UNITED STATES PATENT AND TRADEMARK OFFICE

Office Action Summary

10/502,445

HULSMANN, AXEL

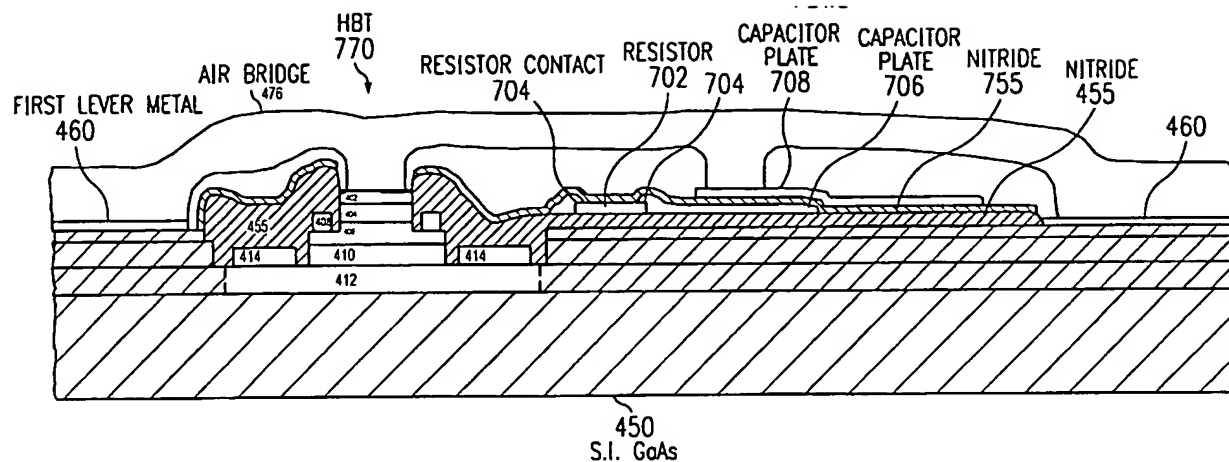
5. Regarding claim 1, Hill discloses an integrated circuit arrangement (col 8 ln 16-18) on the basis of III/V semiconductors (col 3 ln 22), comprising at least one active component (770; col 8 ln 17) and a multilayer configuration of wiring levels (414, 460, 704, 706, 708; col 7 ln 65, col 8 ln 5, 8) characterized in that a metallization layer comprising a metal contact (414; col 4 ln 27) of the at least one active component is formed to be a lower one of the wiring levels (414 is a wiring level: Fig 4L, also 4M).

6. Regarding claim 9, Hill discloses the integrated circuit arrangement as claimed in claim 1, characterized in that the at least one active semiconductor component (770) is a transistor (col 8 ln 17, col 3 ln 14-15) and a metal contact (414) of the collector (col 4 ln 27) of the transistor is formed by means of the metallization layer.

9. Regarding claim 3, Hill discloses the integrated circuit arrangement as claimed in claim 1, characterized that an electric resistor is formed in a wiring level (704) by means of an interruption (702; col 7 ln 61) in the metallization layer. Hill does not disclose this resistor is formed in the lower wiring level. However, such difference is regarded as nothing more than an obvious design choice. That is, varying parameters such as circuit connections and the location of the resistor in the integrated circuit merely requires routine experimentation. Therefore, it would have been obvious to a person of ordinary skill in the art at the time of the invention to adjust the location of the resistor to the lower wiring level.

11. Regarding claim 2, Hill discloses the integrated circuit arrangement as claimed in claim 1, characterized in that a passivation layer (455; col 4 ln 41) is applied on the metallization layer of the at least one active component (455 is on 414), but does not disclose the passivation layer made of a material which has a small relative dielectric constant ($\epsilon_r < 3$). Ko is analogous art that teaches a small dielectric constant below 3 is preferred ([0005] ln 8-14, [0007] ln 18). The field of endeavor is monolithic microwave integrated circuits for both Hill (col 3 ln 5-10) and Ko ([0032] ln 5). Therefore, it would have been obvious to a person of ordinary skill in the art at the time of the invention to

12. Regarding claim 4, Hill discloses that a central wiring level (702+704+706; col 7 ln 60-65) is disposed above the passivation layer (455) and covered by another passivation layer (755; col 8 ln 5-6) made of a material which has a mean relative dielectric constant ϵ_r2 ($\epsilon_r2 > \epsilon_r1$). Hill inherently meets the limitation of the claim, since it discloses the passivation layer material is silicon nitride; which is known in the art to have a dielectric constant larger than [ϵ_r1 , which is less than] 3 (see the entry for silicon nitride on <http://www.semiconductorglossary.com>, for example).

13. Regarding claim 5, Hill discloses that an upper wiring level (708, 476; col 8 ln 8, col 5 ln 12) is disposed above the central passivation layer.

14. Regarding claim 6, Hill discloses that a capacitive component (706+755+708; col 7 ln 65, col 8 ln 5-9) is formed by means of a section (706) of the central wiring level and a section (708) of the upper wiring level.

23. Examiner does not concur that "Hill fails to show anticipation of a metallization layer comprising a metal contact of at least one active component formed to be a lower one of the wiring levels, as required in...claim 1." As outlined in the rejection of claim 1 in this office action, Hill discloses, *inter alia*, "a metal contact (414) of the at least one active component (770) is formed to be a lower one of the wiring levels (414)." Applicant presents neither claim language nor evidence to structurally distinguish Hill's collector contact (Fig 4m: 414) from "a lower one of the wiring levels."
